DESCRIPTIVE REPORT

~~Topographic~~
Hydrographic } Sheet No. 85717

Vicinity of St. Helena Sound

Johnson Creek to Skull Inlet

H-5717

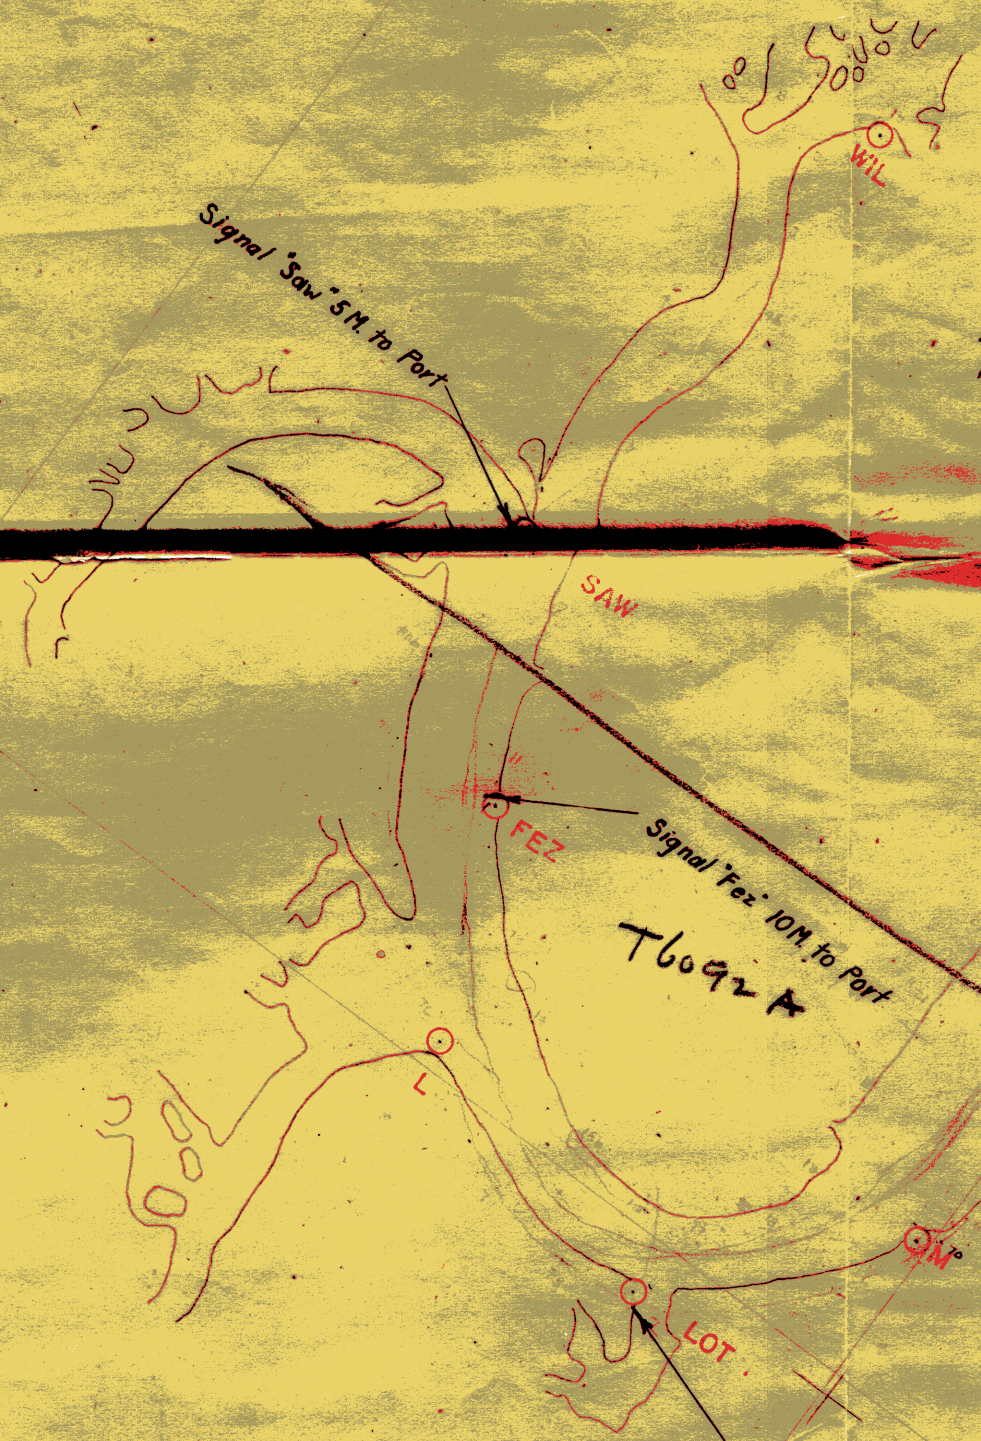
I am mailing you under separate cover a tracing of the section of hydrographic sheet No. 8. The shore-line as shown on this sheet is a careful tracing of the 1/10,000 enlargement made by Lt. Kirsch from the aerial-photographs. The green dots are the actual smooth-plotted positions obtained by using the control as located on the topographic sheet. You will note that the hydrography does not conform with the shore-line. We have carefully checked the compilation in this area two different times taking additional well defined points from signal ZEV around to signal SAW and we are unable to find any discrepancy. Signal ZEV which is located on the end of a dock fails to check the position obtained by radial plot. Assuming that the radial plot is correct, and we have very strong reasons for assuming that it is correct, this would indicate that there is an error in the topography.

On the other hand, by shifting the shore-line by an amount equal to that shown by the two crosses at lat. $32^{\circ} 22'$, the shore-line would then conform to the hydrography. Only the outside lines of the hydrography in this area has been shown on the tracing. Another thing that leads me to believe that there is an error in the topography is a note stating that the sounding launch passed signal LOT on line 72-73, and LOT was 3 meters to port, while the line as plotted shows that LOT would be on the starboard.

Signal Saw 5 M. to Port

Signal Tree 10 M. to Port
T6092b

Signal Lot 3 M. to Port

Line Breaks 7 M. from Dock.
Blue shows position of dock from photo compilation
Black shows position of dock from tracing of Top sheet 'D'

It was found that by tracing all the hydrography as plotted on the signals as located on the smooth sheet, and slightly moving this tracing of all the hydrographic positions as a unit, the sounding lines could be brought into agreement with the compiled shoreline. The amount of change at lat. $32^{\circ} 22'$, long. $80^{\circ} 27'$ was 23 meters north, 10 meters west, with a positive change in azimuth of $0^{\circ} 48' 15''$. This change was made to all positions south of $32^{\circ} 22.2'$ on Johnson Creek. Above that point no change was made.

The greatest change occurred from Lat 32-22.0 Long 80-27.0 west and north to the limits of the sheet where the change was ^{with a pos. change in azimuth of approx 0°48'} approximately 22 meters north and 10 meters west. From the above latitude and longitude eastward the change was proportionally less to Lat. 32-23.2 Long 80-26.6 where the positions and soundings are plotted from the record. All positions and
